FORD E40D "UPDATE HANDBOOK"

INTRODUCTION FORD E4OD "UPDATE HANDBOOK"

**FORD E40D
VALVE BODY, SPACER PLATE, SPACER PLATE GASKETS,
CHECKBALL LOCATIONS, AND CASE CHANGES,
FOR THE 1996 MODEL YEAR**

Figure 47
AUTOMATIC TRANSMISSION SERVICE GROUP

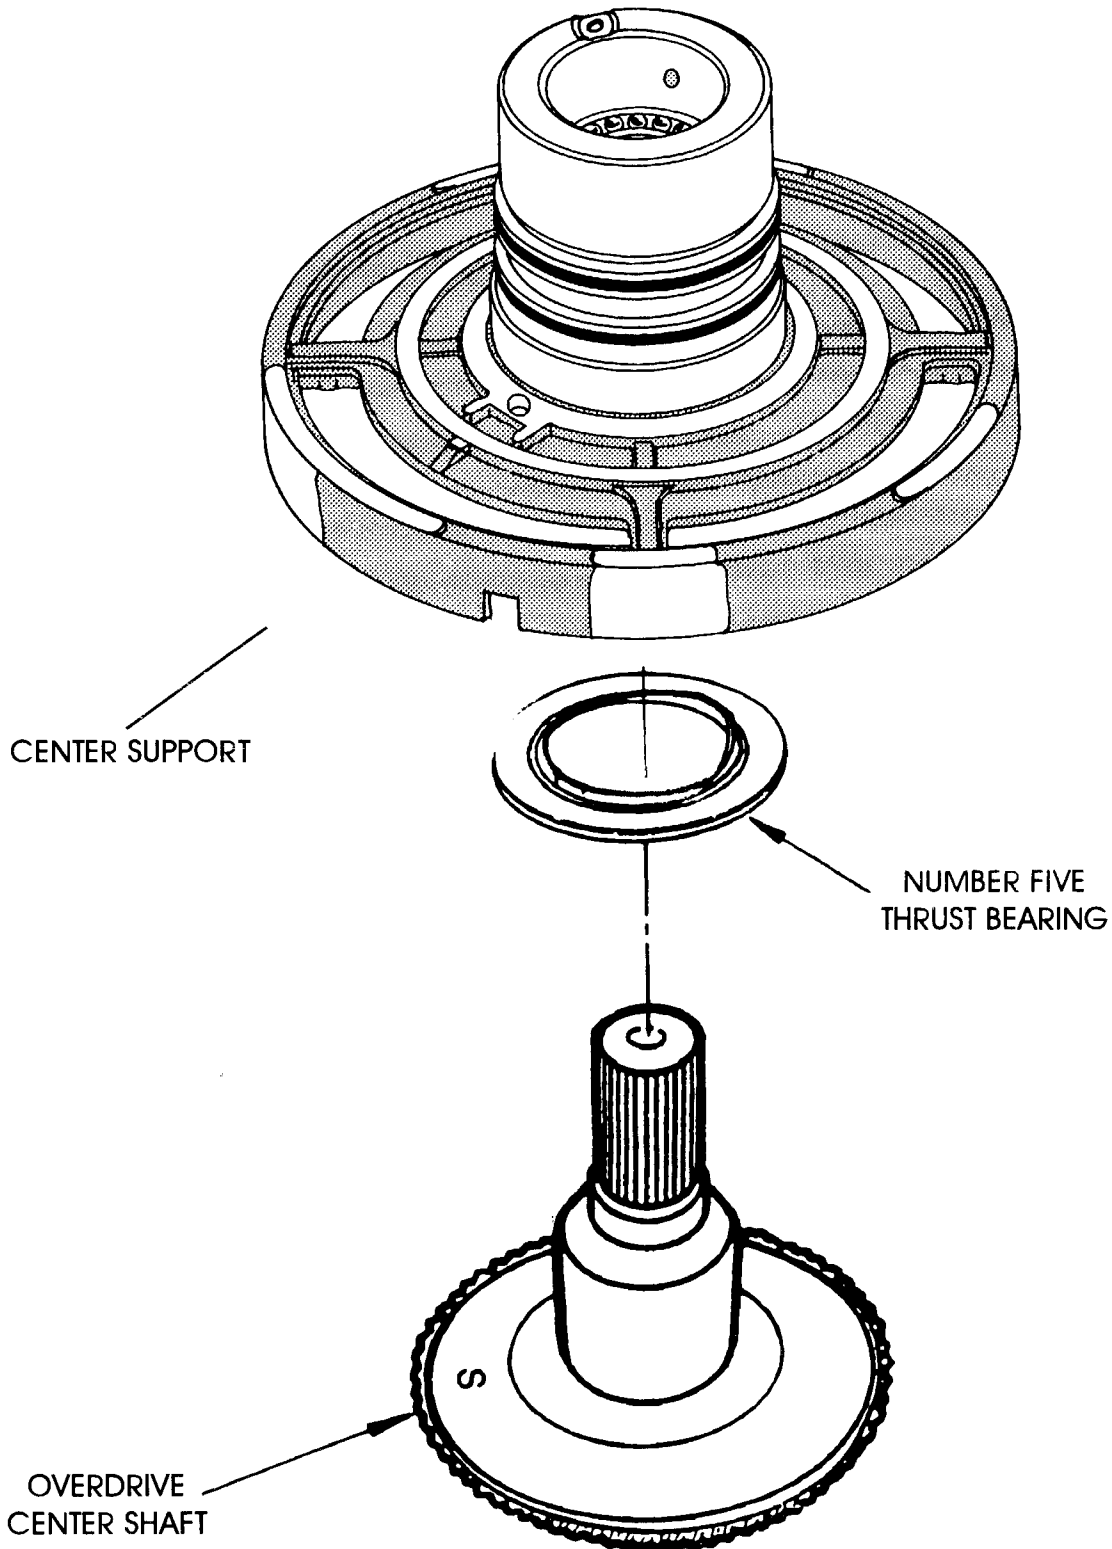
- (4) NO. 5 NEEDLE BEARING - Make certain the No. 5 Needle Bearing included in the service kit is installed with the service kit *regardless* of whether your unit had one or did not have one. Some 1994 model year transmissions were built with some or all of the parts that "Resemble" the parts in this service kit, and may or may not have a No. 5 needle bearing. Make certain that the No. 5 needle bearing from the service kit is installed. Refer to Figure 47 for proper installation of the needle bearing.

Figure 48
AUTOMATIC TRANSMISSION SERVICE GROUP

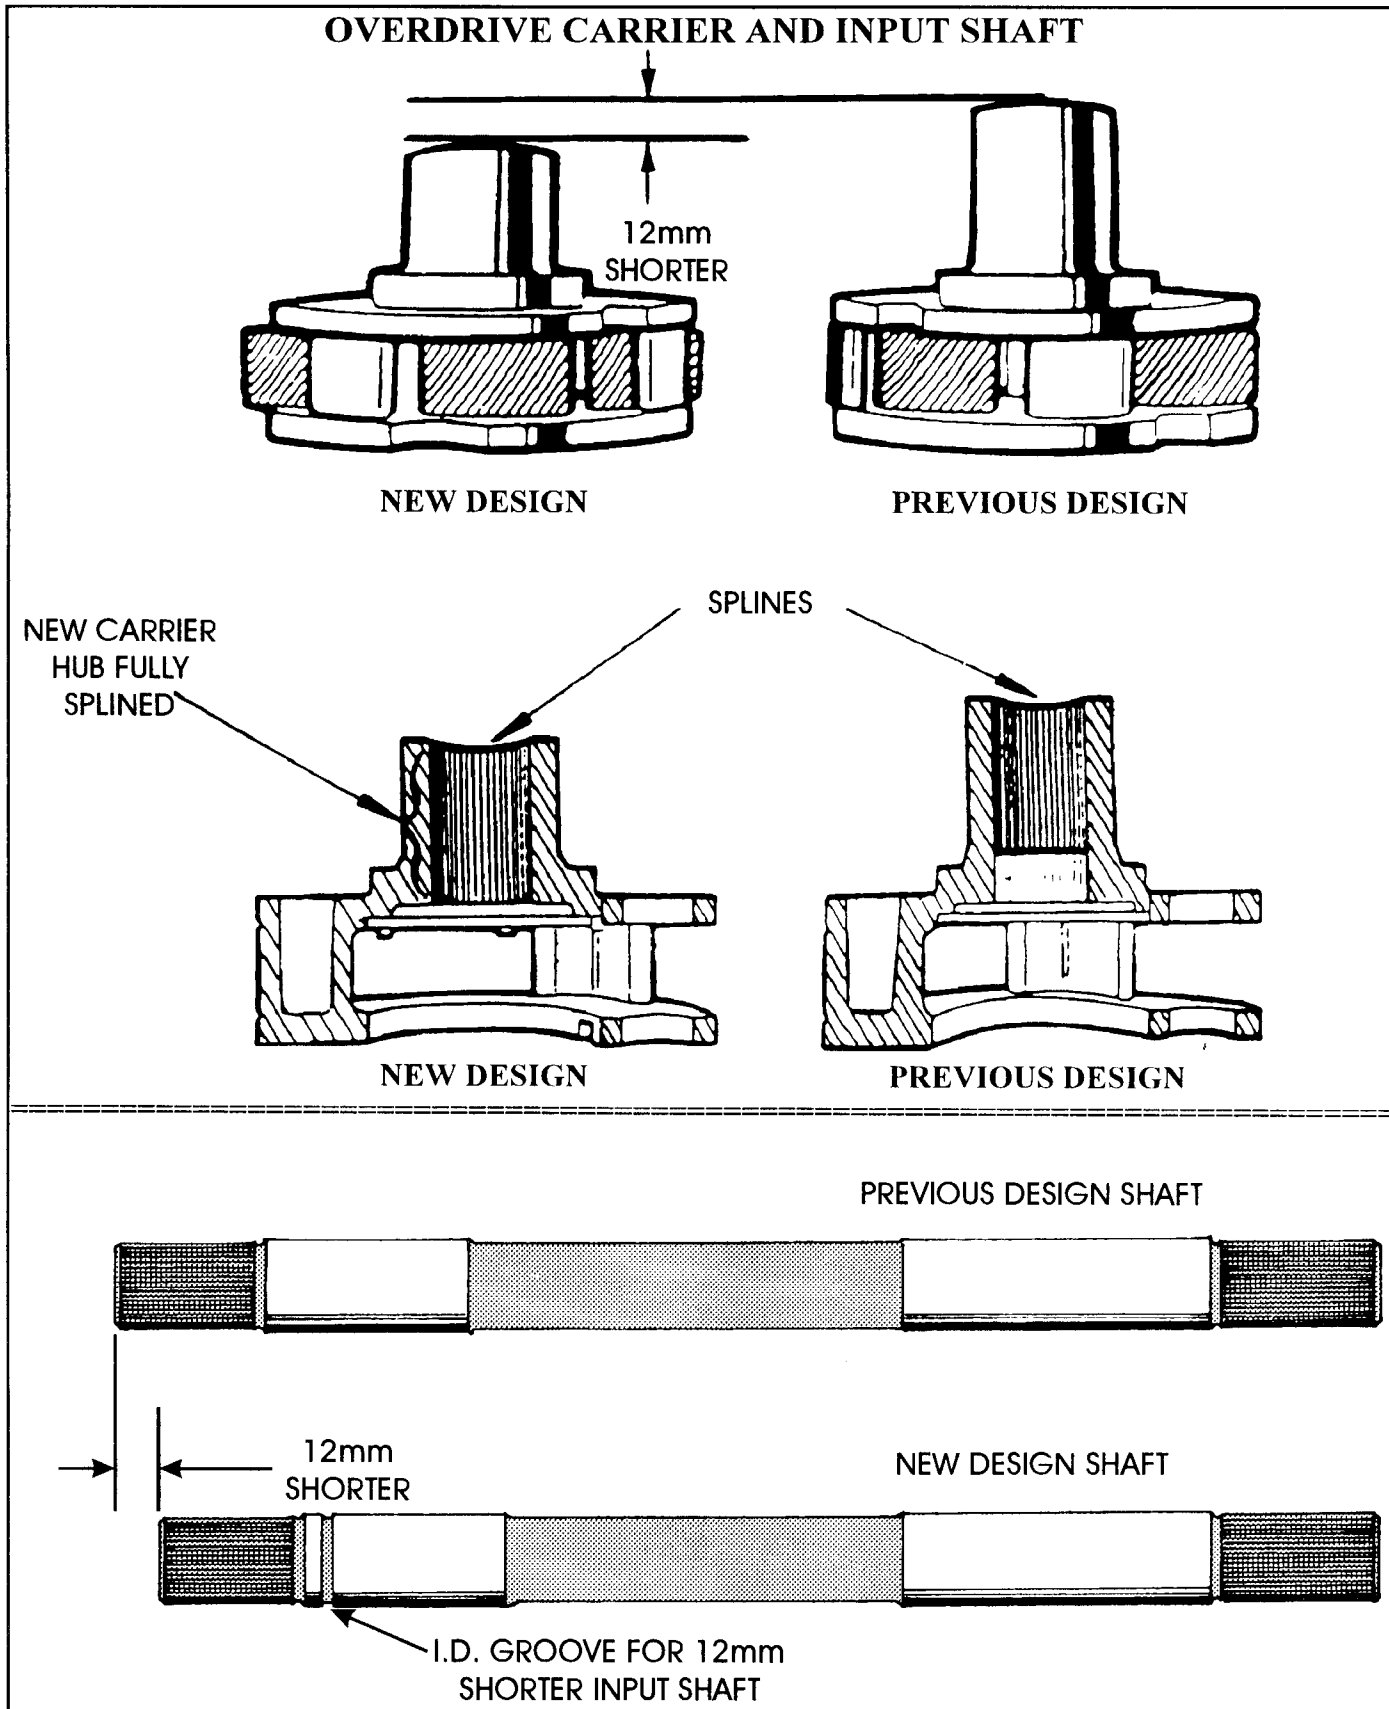
- (2) OVERDRIVE CENTER SHAFT - Different machining dimensions on the center shaft to accommodate the added ball bearing, and the pilot on the center shaft has been removed. The new design Overdrive Center Shaft can be identified as a "Service Part", by the letter "S" stamped on the shaft in one of two locations, as shown in Figure 45. The Service Kit Overdrive Center Shaft has different dimensions than 1995 model year production center shaft. Refer to Dimensions "A" and "B" in the cutaway drawing shown in Figure 45.
Special Note: There is also an updated Overdrive Carrier and Input Shaft, available under OEM part number F4TZ-7B446-B, to help improve durability. Both pieces have different dimensions than the previous parts, as shown in Figure 48. The new overdrive carrier hub is 12mm (.472") shorter than the previous models, and the internal splines now run the full length of the hub which makes it stronger. The Input Shaft is also 12mm (.472") shorter than the previous models, to accommodate the new overdrive carrier, and has an I.D. groove cut in the shaft for identification (See Figure 48).

Figure 51

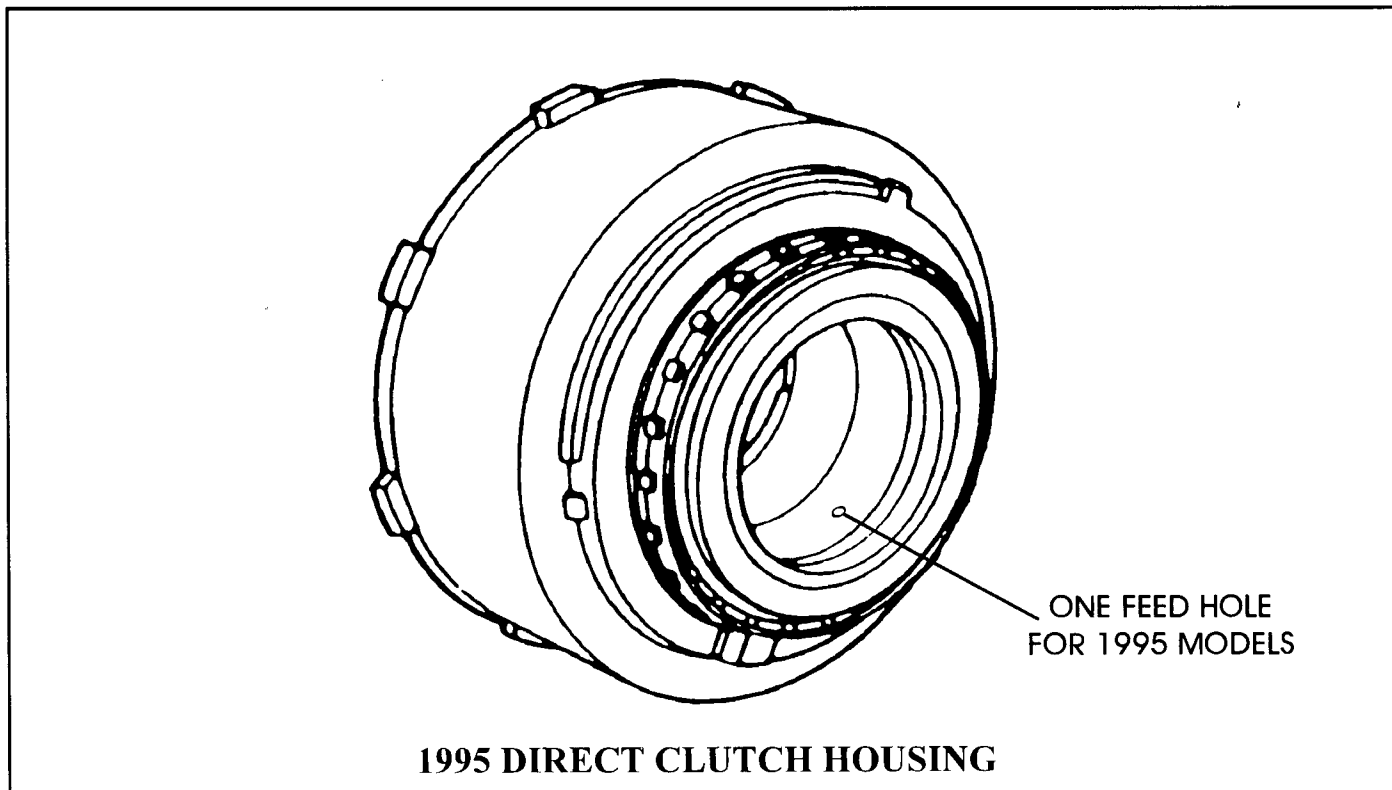
CHANGE: Beginning at the start of production for the 1995 model year, all E4OD transmissions were built with a revised Direct Clutch Housing (Intermediate Brake Drum) as shown in Figure 51.

(1) DIRECT CLUTCH HOUSING - 1995 models now have only *one* direct clutch apply pressure feed hole, instead of the *two* feed holes found in previous models (See Figure 51).

Figure 52

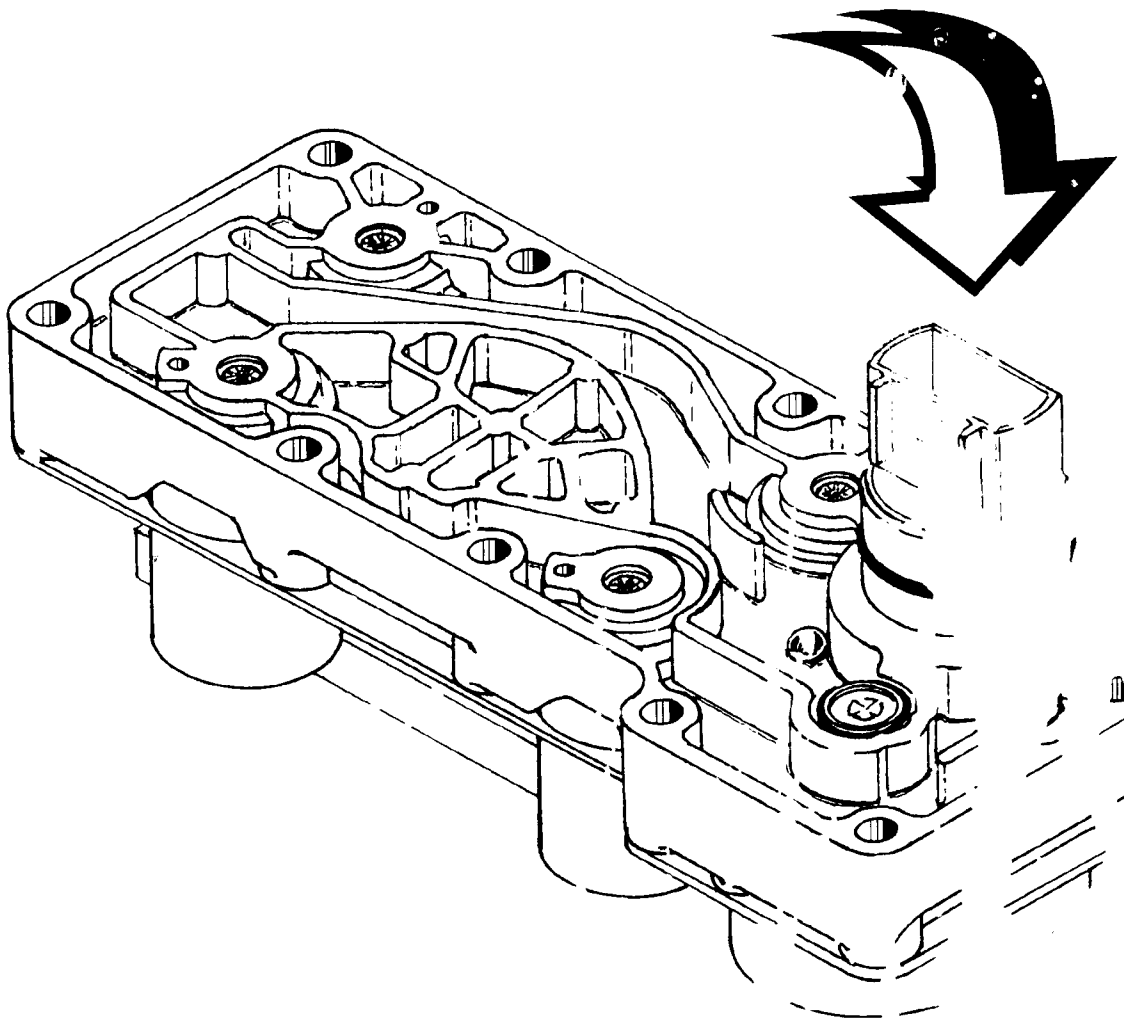
- (1) **SOLENOID PACK** - New design solenoid assembly case connector to accommodate the new design vehicle harness connector. Refer to Figure 52 for identification of the previous design and the new design solenoid assemblies.

NOTE: The plastic sleeve incorporated in the previous design solenoid pack has been eliminated on the new design solenoid pack (See Figures 52 and 53). This plastic sleeve will sometimes remain on the vehicle harness connector when it is disconnected. If a new solenoid pack is installed (which includes sleeve), it will be impossible to reconnect the vehicle harness to the solenoid pack until the old sleeve is removed from vehicle harness connector. Refer to Figure 53.

Figure 54

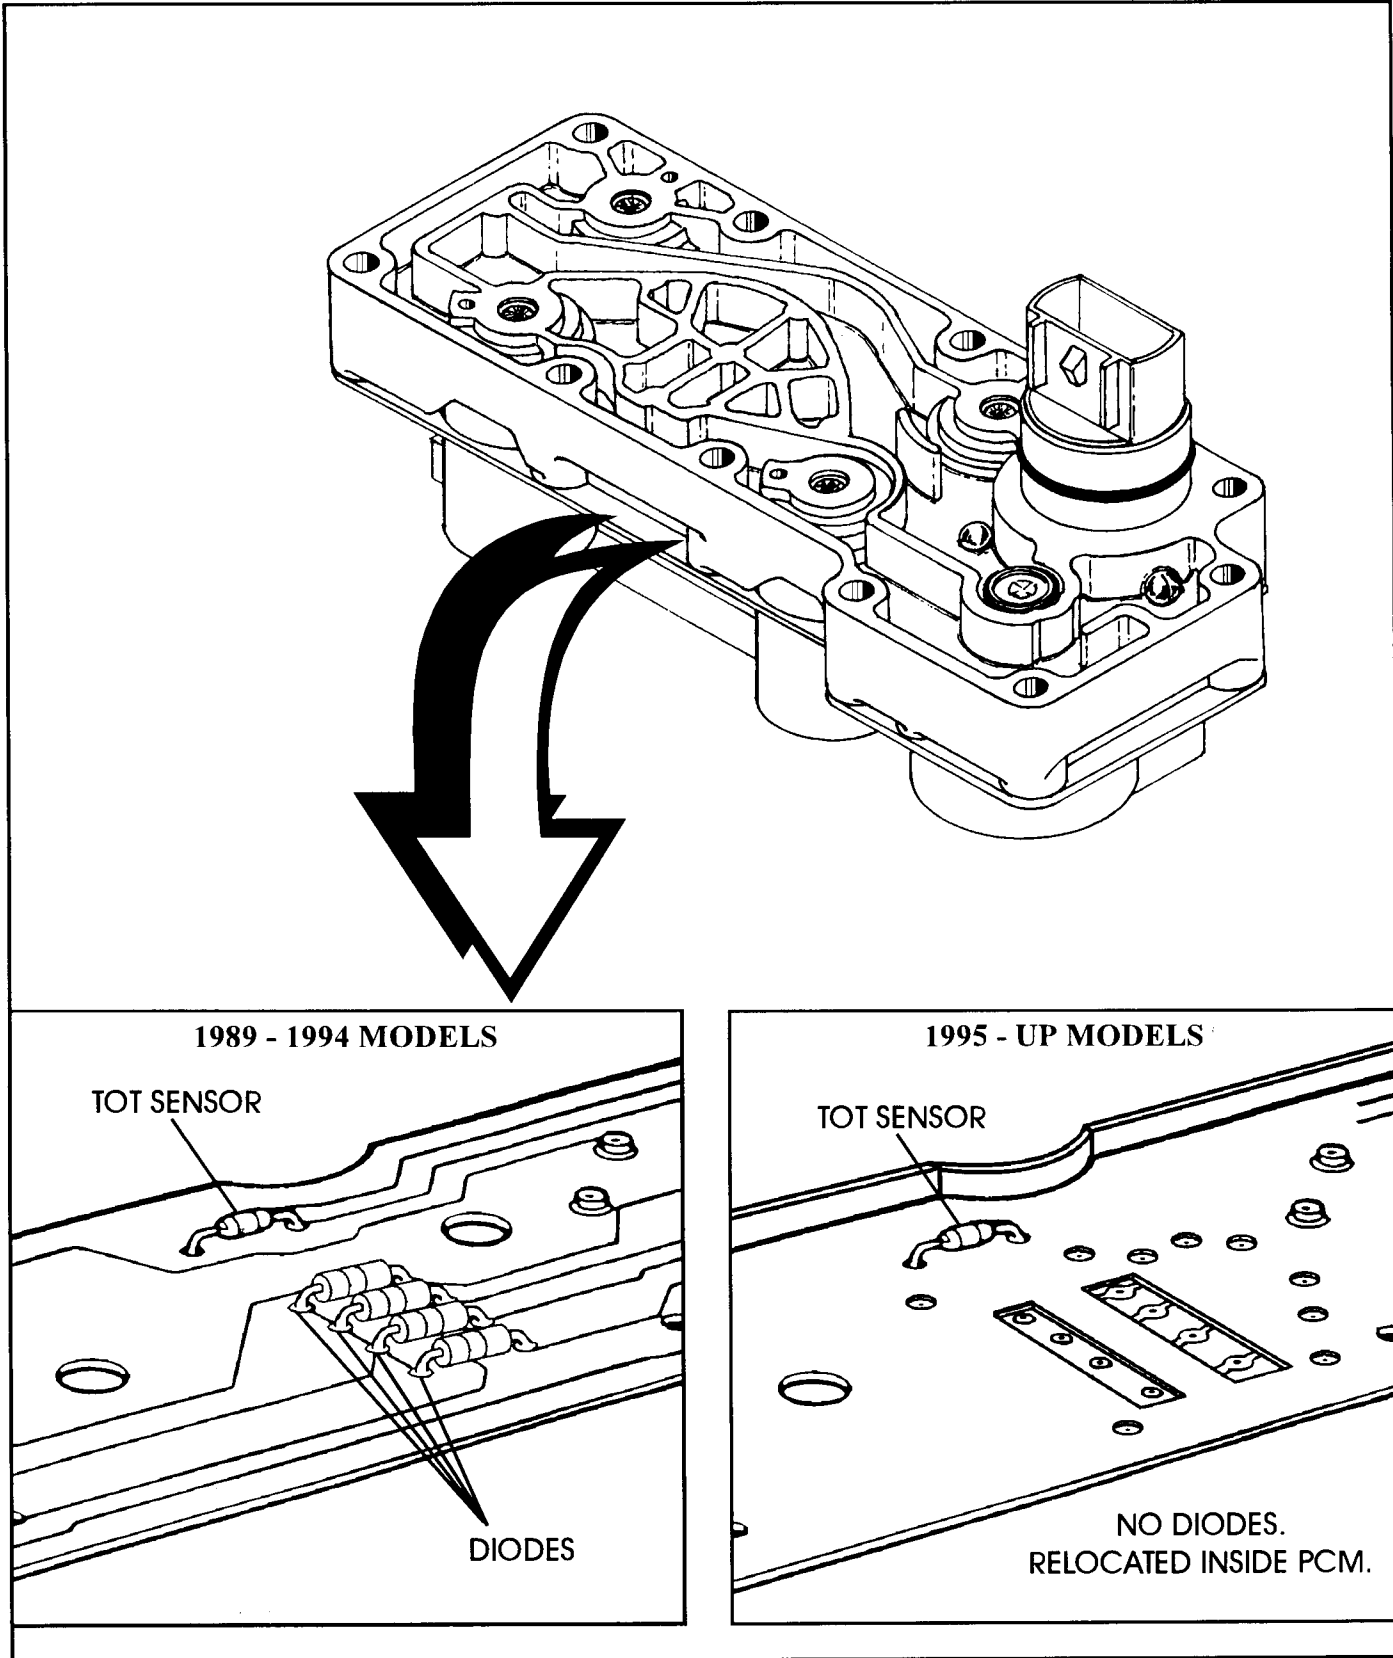
CHANGE: Beginning at the start of production for 1995, all models of the E4OD transmission were produced using a new design solenoid pack, that will not interchange with previous models, as the internal diodes have been eliminated and put into the PCM (See Figure 54)

They will not interchange because in 1995 models the diodes for the solenoids were moved out of the solenoid pack and placed into the PCM (See Figure 54).
